Re: Response to Request for Further Information – Section 92 RMA

Application: BUN60453420 (LUC60453421 and DIS60453422)

We write in response to Council's Section 92 Request for Further Information (dated 13 August 2025) for the above application. The following responses address items 2, 5, 6, 7, 8, 11, and 16–20 of the request.

DWG SITE INVESTIGATION PLAN

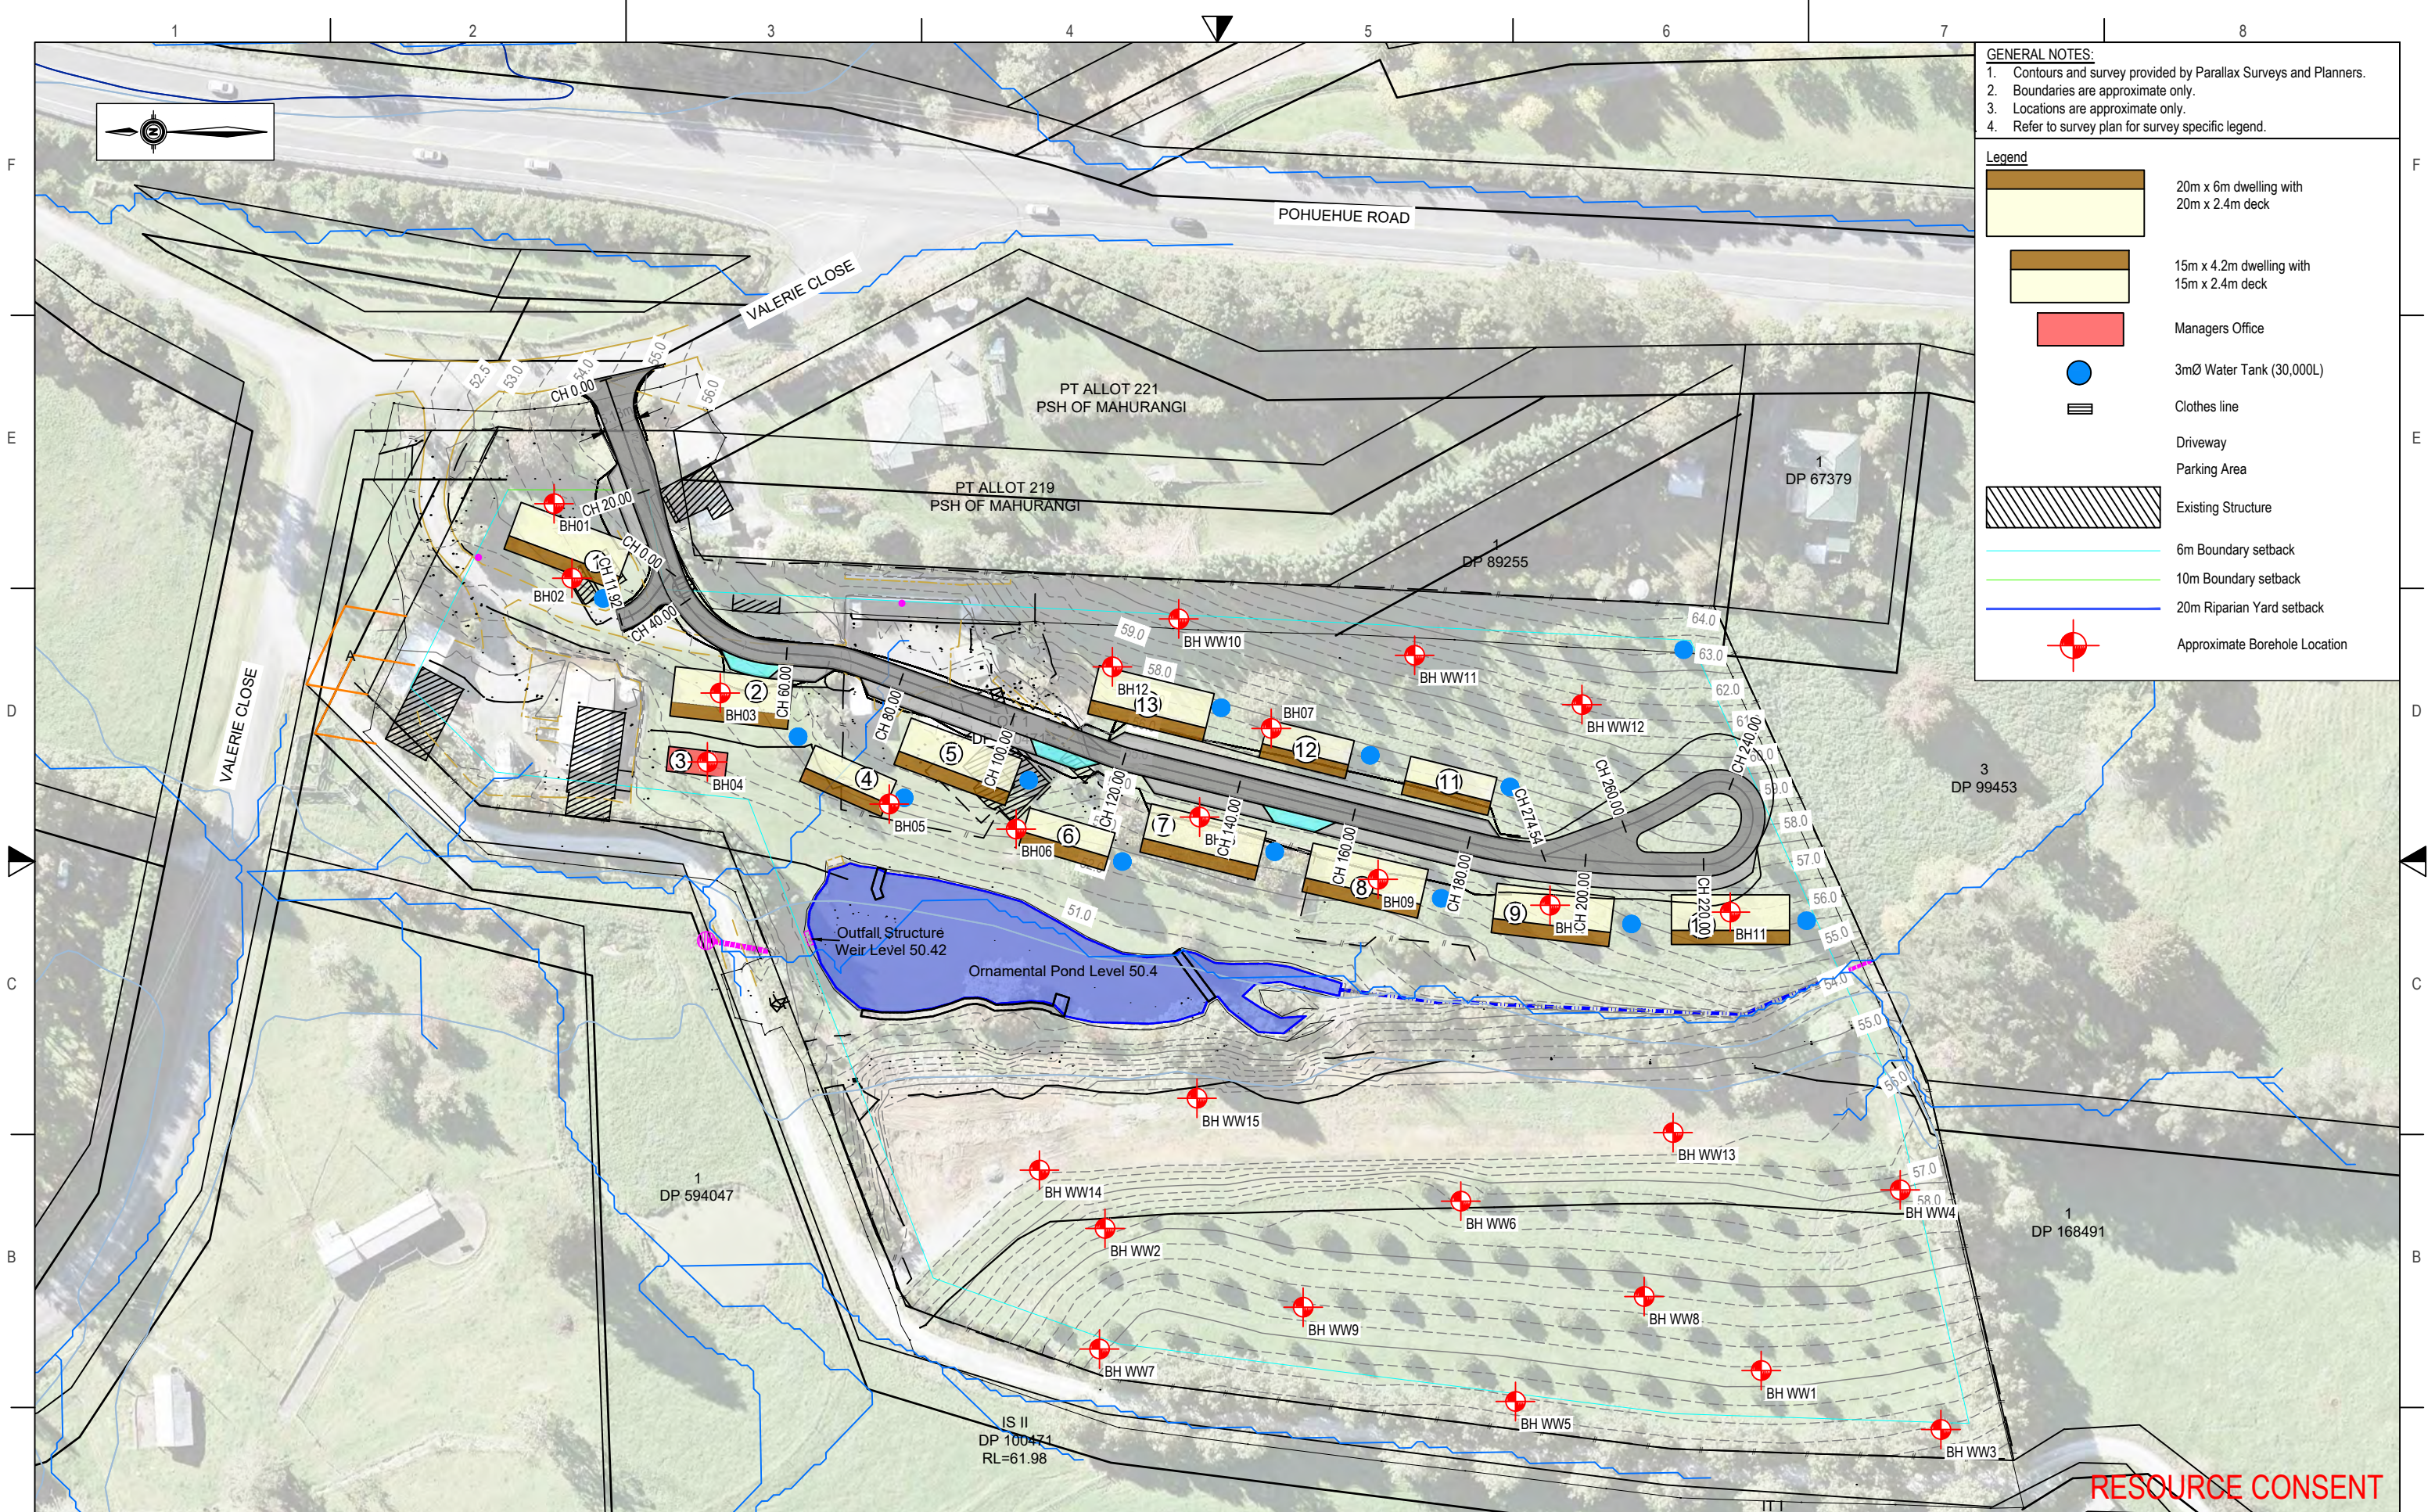
Q18. There are only two boreholes in the wastewater disposal fields ... Please address this.

An additional 13 boreholes have been carried out. Due to the consistency of results, further boreholes are considered to be excessive. The soil category allocated is also conservative. Logs of the additional boreholes are provided in Appendix B and locations of additional boreholes are included in Appendix A – Site Investigation Plan GEO-02 and W-01.
